City of Dublin

# Memo

**To:** Members of Dublin City Council  
**From:** Dana L. McDaniel, City Manager  
**Date:** October 15, 2019  
**Initiated** Jennifer M. Rauch, AICP, Interim Planning Director  
**By:** Claudia D. Husak, AICP, Senior Planner  
**Re:** Ord. 53-19  
Rezoning approximately 33.9 acres south of U.S. 33, east of Eiterman Road and north of Shier Rings Road from ID-1, Research/Office District to PUD, Planned Unit Development District (The Ohio State University Wexner Medical Center) for the construction of up to 550,000 square feet of ambulatory medical care, medical and office uses and a future hospital in two phases (Case 19-055Z/PDP)

This Ordinance is a request for review and approval of a rezoning of 33.9 acres south of U.S. 33, east of Eiterman Road and north of Shier Rings Road from ID-1, Research/Office District to PUD, Planned Unit Development District (The Ohio State University Wexner Medical Center) for the construction of up to 550,000 square feet of ambulatory medical care, medical and office uses and a future hospital in two phases (Case 19-055Z/PDP)

① Primary Entry Monument Sign

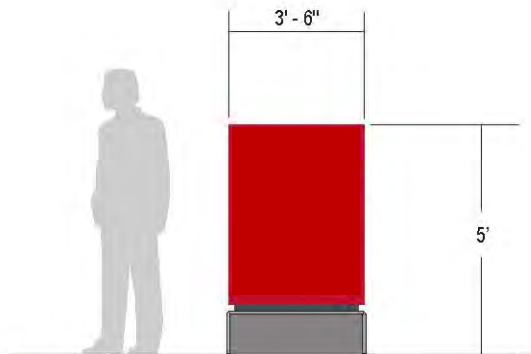
- Primary Entry Monument Sign: The text permits one such sign either east or west of the main entrance to the facility. The sign plan shows the height of this sign to be approximately 12 feet and the overall size is 66 square feet. At the Final Development Plan Stage, the applicant will have to verify that this sign does not impede visibility for this intersection.

② Secondary Entry Monument Sign

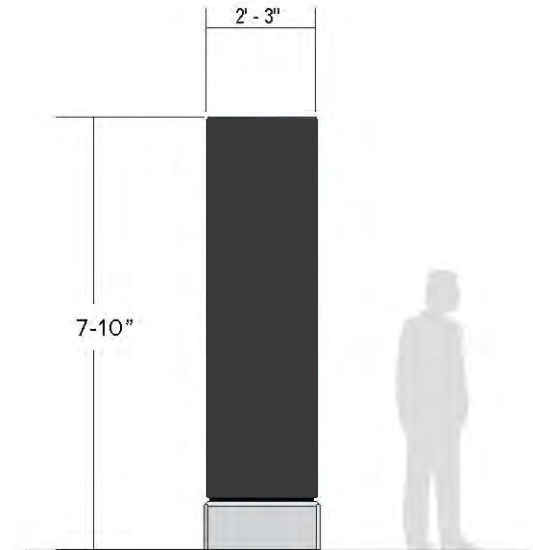
- Secondary Entry Monument Signs: the text permits two of these types of signs at the westernmost and easternmost access drive into the site. The sign plan shows that these signs may be five feet tall and 3'6" wide for a total size of 17.5 square feet. The sign plan indicates four locations for these signs while the text limits them to two. The applicant needs to address this discrepancy.
